Docket Item # 2  
BAR CASE # 2010-0063

BAR Meeting  
May 5, 2010

**ISSUE:** Signage and Awning Replacement  
**APPLICANT:** Bittersweet (Robert Blumel, Agent)  
**LOCATION:** 821 King Street  
**ZONE:** KR / King Street Retail Zone

Figure 1. Existing signage on Alfred and King Street Elevations

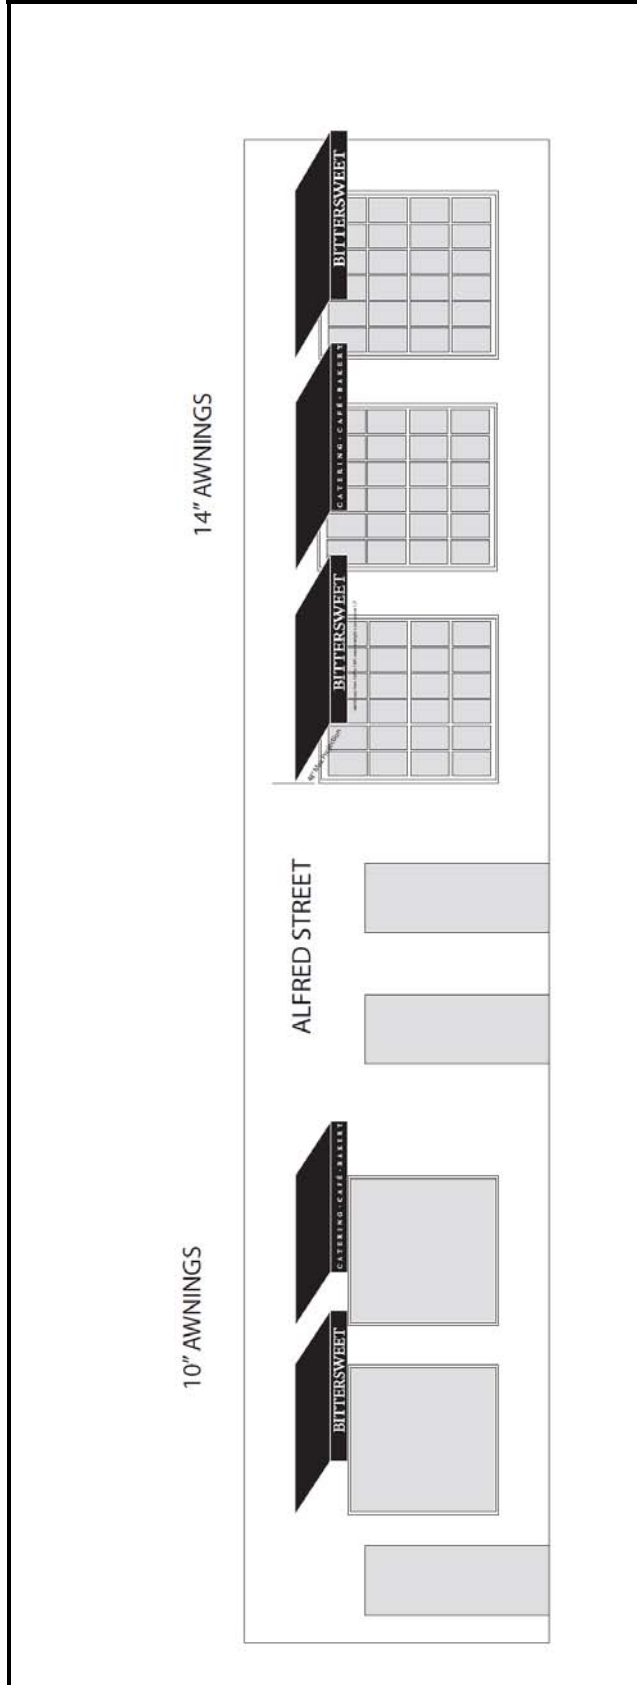
At the April 21, 2010 BAR hearing, the Board removed this item from the Consent Calendar. Although there were no stated concerns about the design of the requested awnings, Board members expressed concern about the amount of existing signage on the windows of the business, and asked the applicant to study their overall signage plan. The applicant has evaluated their signage and has revised the submitted proposal as follows:

1. Remove of the round, 35” diameter, anniversary decals on the two, Alfred Street windows.
2. Remove the 2003, 2006 Award Decals on the upper, front, right window.
3. Remove the signs hanging from the “clothesline” from the lower, front, left, window.

Figure 2. Alfred Street Elevation Proposed

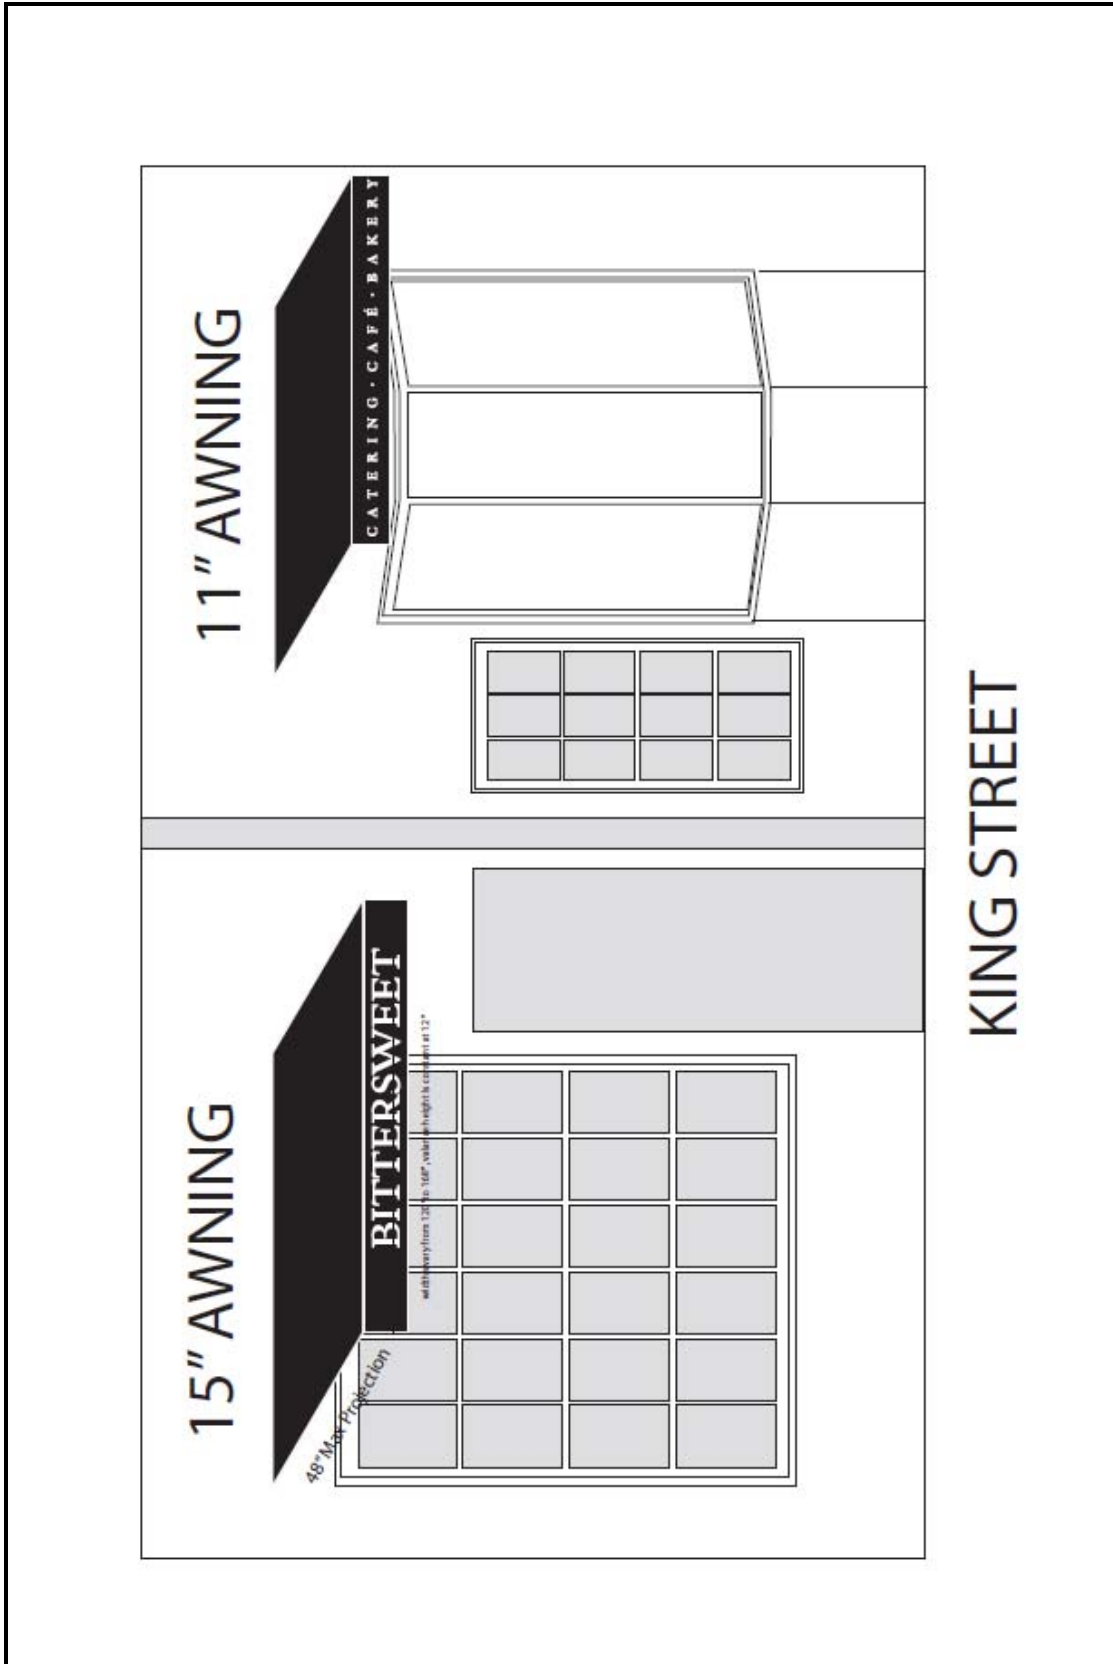
The proposed awning’s widths vary from 10’-14’ with a 12” valance and are fabricated of a metal frame sheathed with Sunbrella fabric. These specifications meet the requirements outlined in the *Design Guidelines* for size, design, mounting specifications and materials. Additionally, the proposed awnings do not detract from the current style of the building and are similar to retractable awnings the Board has approved on other establishments within the historic district (see photo below of retractable awnings approved at 1025 King Street, Catholic Book Store.)

The proposed awnings at Bittersweet are very simple and elegant black with white lettering and have greatly reduced the bulk and signage of the present awnings. The applicant is proposing to mount the awning to the building by utilizing bolts installed into the frieze of the trim above the windows or in the masonry’s mortar joints. As requested by the Board, the area of the window signs will be reduced by over 50%. The remainder of the small white vinyl signs are tasteful, are similar to window signs previously approved by the Board, and comply with the Zoning Ordinance.
